ADDENDUM NO. 1

Notice to All Persons and Firms Proposing to Submit a Bid or Furnish Materials for
West Adams Avenue Resurfacing and Adams Avenue-Ballas Road – ARS Infrastructure
St. Louis County Project No. AR-1681 and AR-1479
Federal Project No. STP-5641(603) and STP-5461(602)

DESIGNED:	J. BIRKE
DRAWN:	D. MICKE
CHECKED:	J. MUES
SHEET SEQUENCE:	7 OF 20

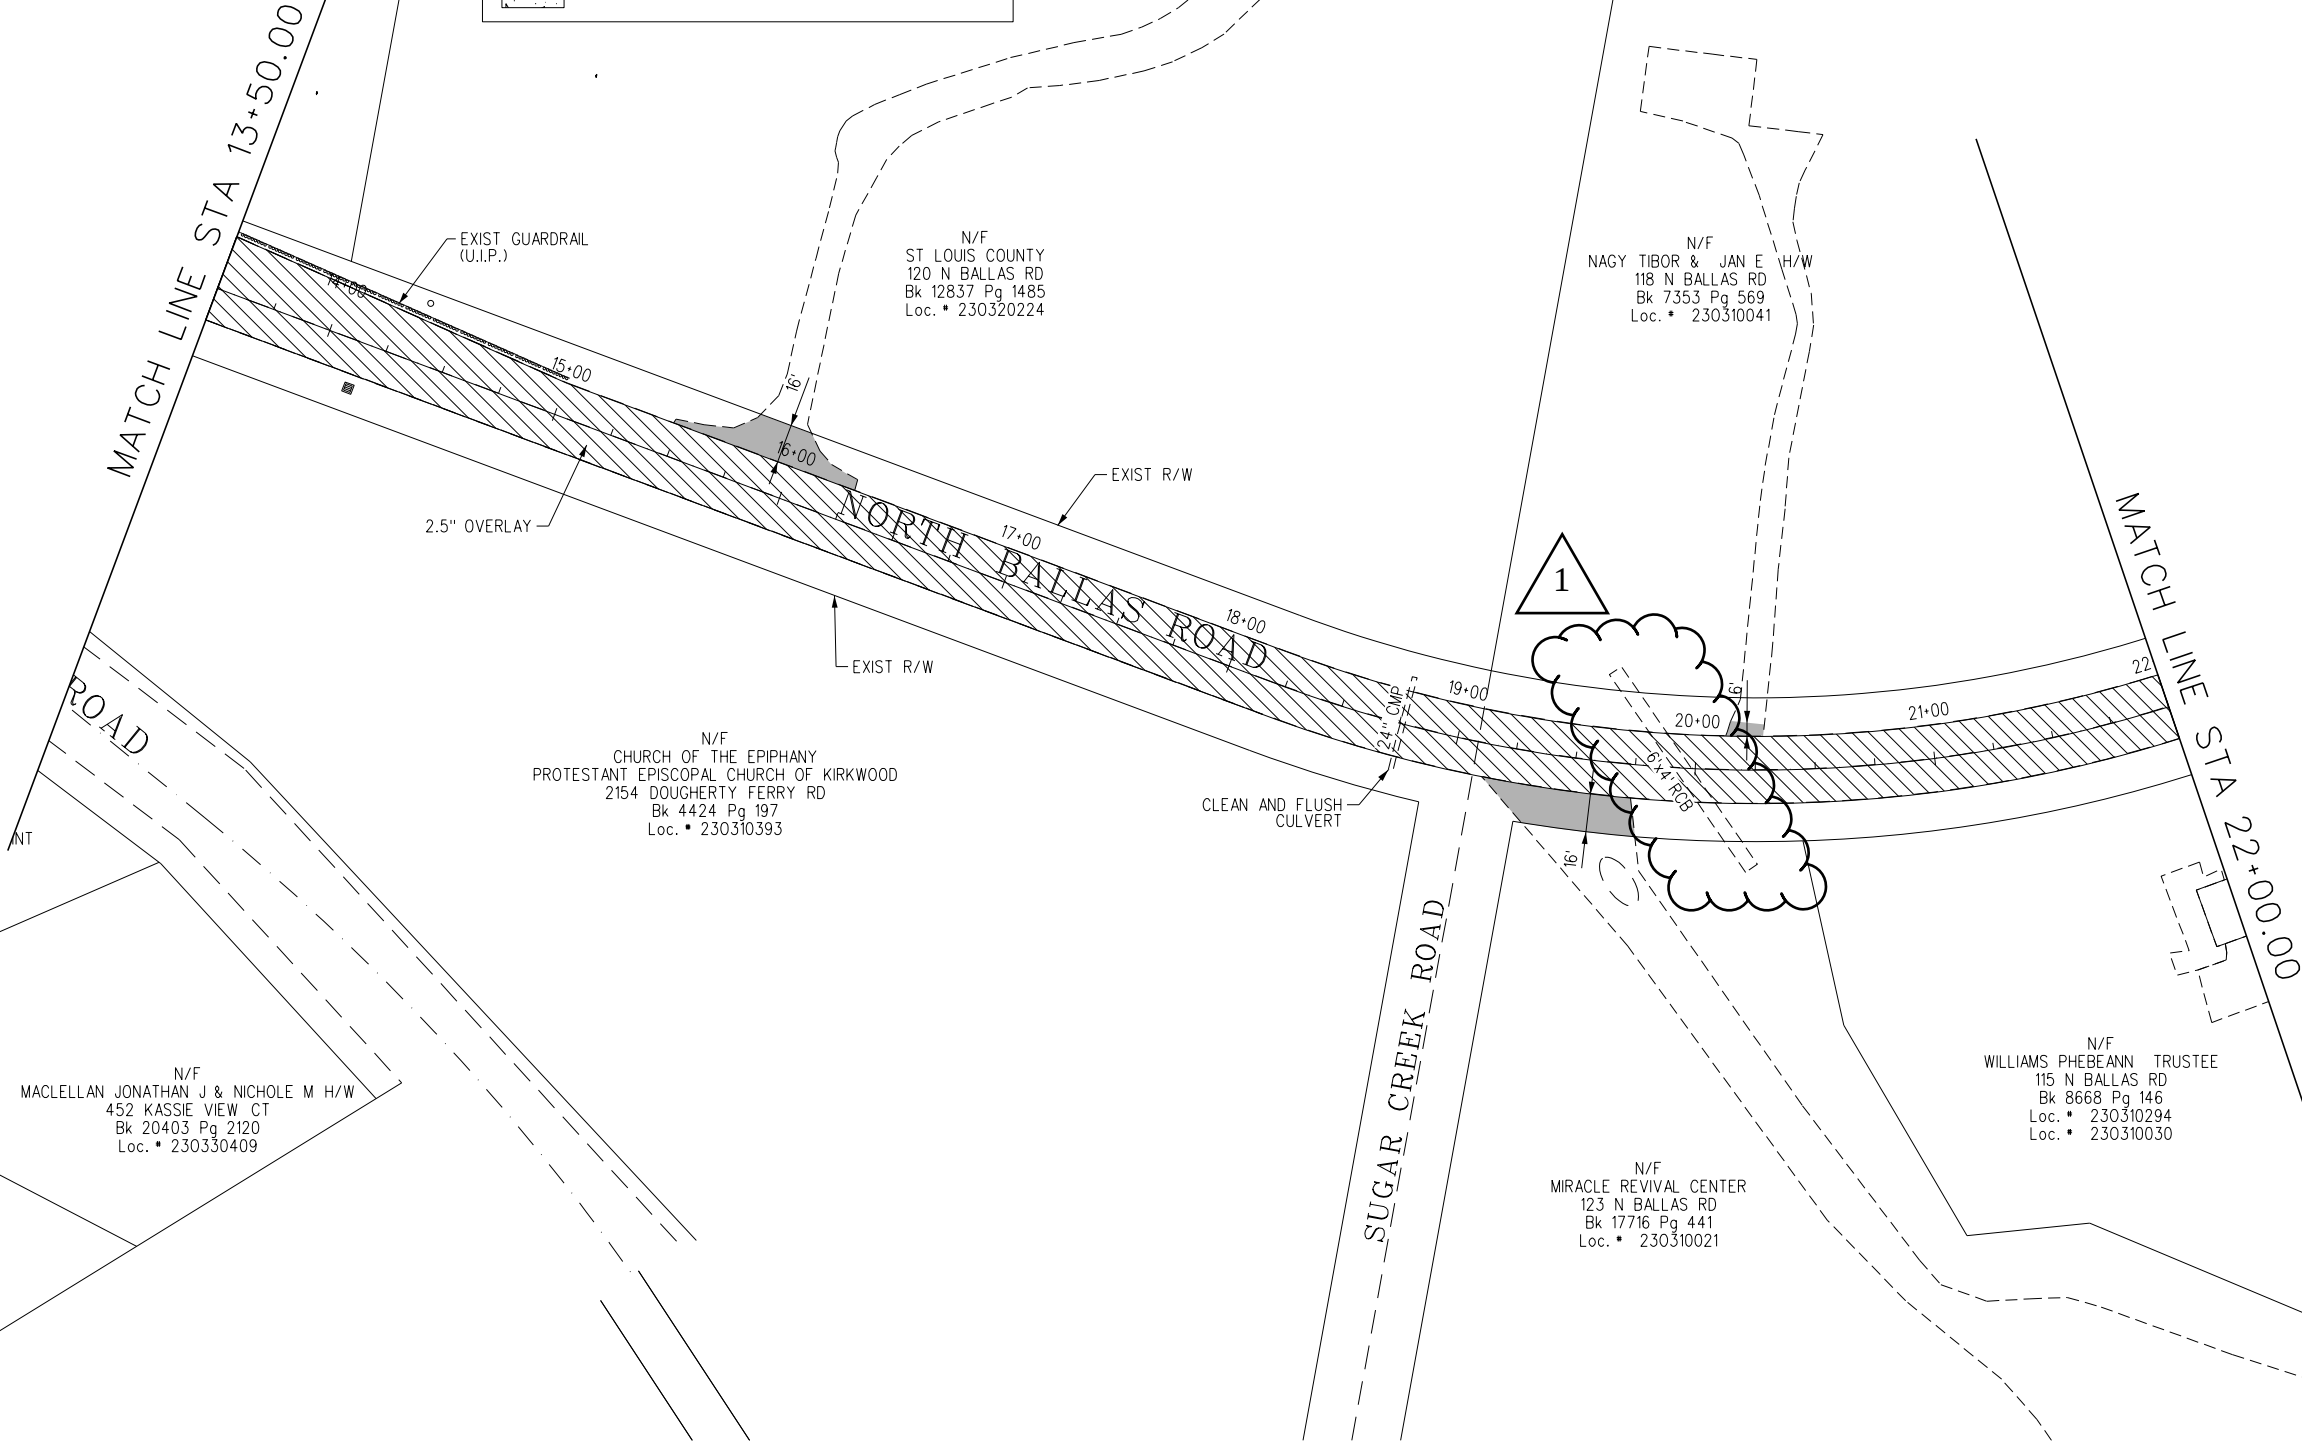
Culvert replacement on North Ballas Road at station 19+62.44 to 20+23.55 has been removed from the project. The following Bid Items have been removed or adjusted:

Replace Sheet 7 of 20, Plan Sheet

COUNTY PROJECT NO.		AR-1479
FEDERAL PROJECT NO.		STP-5641(602)
E-W GATEWAY TIP NO.		6607A-18
MSD:	N/A	
MSD BASE MAP:		230, 23N, 24O
REV.	DATE	DESCRIPTION
1	11/2/17	REMOVAL OF 6' X 4' RCB
